RE: PEER REVIEW – PLANNING PROPOSAL – 445-459 CANTERBURY ROAD, CAMPSIE**1.0 BACKGROUND**

Bitzios Consulting has been engaged by City of Canterbury Bankstown (Council) to undertake a review of the Traffic and Parking Assessment (TPA) report prepared by Varga Traffic Planning for the Planning Proposal for a medical facility at the site of 445-449 Canterbury Road, Campsie (subject site).

Figure 2.4: Stanley Street looking South – Sight Line Obstructions

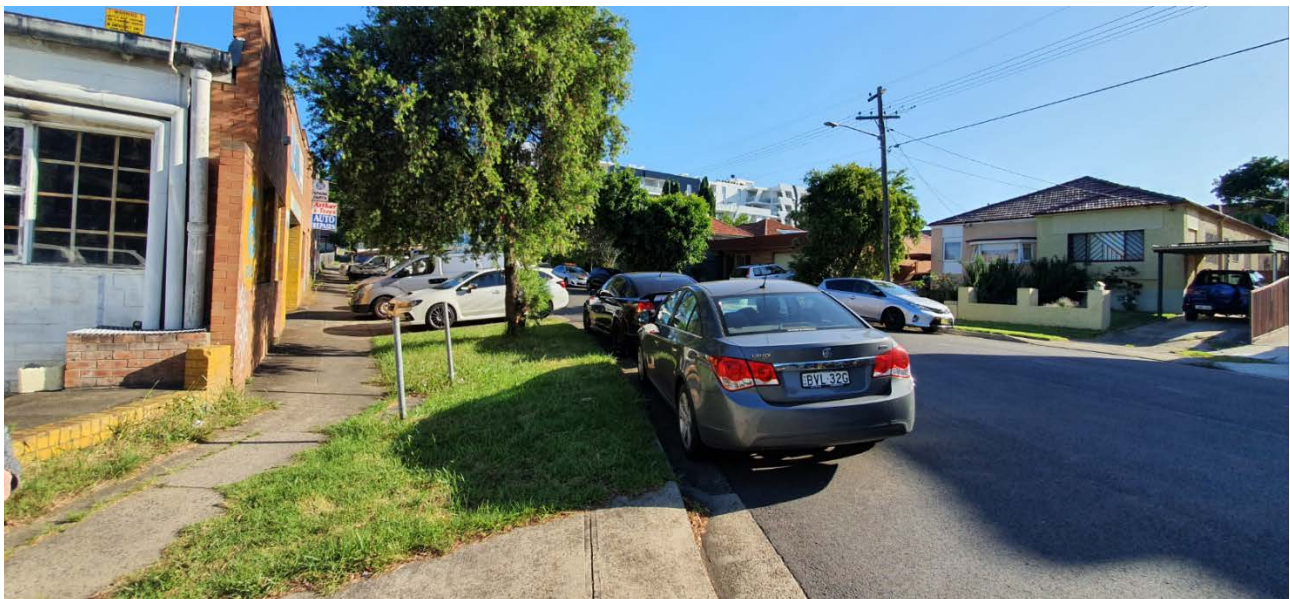
The laneway will be located on a bend in Stanley Street. It was observed that the existing driveway at this location has poor sight lines to traffic approaching from the south caused by parked vehicles and vegetation as shown in Figure 2.4.

Mitigation measures such as parking restrictions around the laneway entrance may be required to provide adequate sight distances for safe access to and from the site.

- Facilitating safe access to the site at the laneway access, to ensure sight line issues caused by road geometry are accounted for.
- Undertaking or funding a parking study to determine the parking impacts caused by the under-provision of parking at the site, and to plan for potential amelioration measures.
- Taking into account a more conservative analysis for the B6 zone uplift.
- Preparing additional modelling scenarios, including Opening Year and Design Horizon years, as well development independent of the B6 zone uplift.
- Identifying the road infrastructure upgrades that will be necessary to accommodate development traffic.
